Admiral 12B1-12B1A-5T4A CHASSIS

Models 632, 633, 634, 642, 643, 644, 649, 654, 662, 663, 664, 671, use Chassis 12B1. Chassis 12B1A has a different panel; used in later Model 649. Same model numbers with prefix SS use auxiliary stereo unit 5T4A.

ADMIRAL Schematic Diagram of 12B1-12B1A Radio Chassis Stamped Runs 10 through 15.

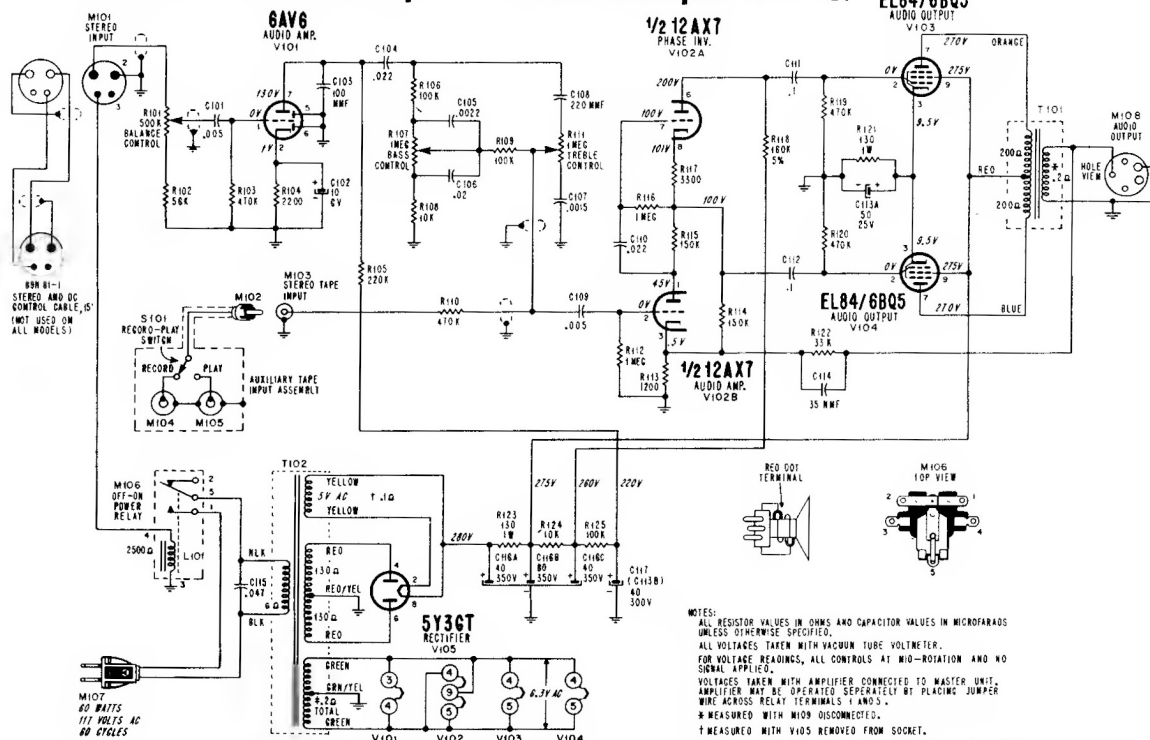
- 10 Start of production 12B1.
- 11 R25 (15K, 1W) changed to (22K, 1W) to permit full interchangeability 6BE6 tubes. R33 changed to (390K, 1/2W); R34 to (100K, 1/2W); and C39 to (.002MF) to improve AM operation. R70 (470K, 1/2W) added between M11 and M12 to minimize rumble.

- 12 R70 (470K, 1/2W) removed to increase channel separation for stereo operation.
- 13 To insure proper operation of OFF-ON-POWER relay at low line voltages, R45 (39K, 2W) removed and R71 (33K, 2W) added in its place.

- 14 To reduce possibility of regeneration in strong signal areas, C18 (.02MF) and C21 (.02MF) removed. R72 (75K, 5%) and R73 (75K, 5%) added to IF section. R65 (60K) connected to B+ 200V. For standardization of parts, C19A and B (dual .004MF; V2 screen and filament bypass) removed. C19 (.01MF) V2 screen bypass and C72 (.005MF) V2 filament bypass added. C22A and B (dual .004MF; V3 screen and filament bypass) removed. C22 (.01MF) V3 screen bypass and C73 (.005MF) V3 filament bypass added. C24A and B (dual .004MF; V4 screen and filament bypass) removed. C24 (.01MF) V4 screen bypass and C74 (.005MF) V4 filament bypass added. V8 changed to ECC83. For improved frequency response, C55 changed to .02MF. C64 changed to .02MF. C66 and C67 each changed to .02MF. C75 (.001MF) added from plate to screen of V12. To increase AM audio output, R33 changed to 100K and R34 changed to 390K. R74 (100K, 1W) added.

- 15 R75 (10 ohms, 1/2 watt) added between pin 2 of V18 and R2 to reduce possibility of RF regeneration.
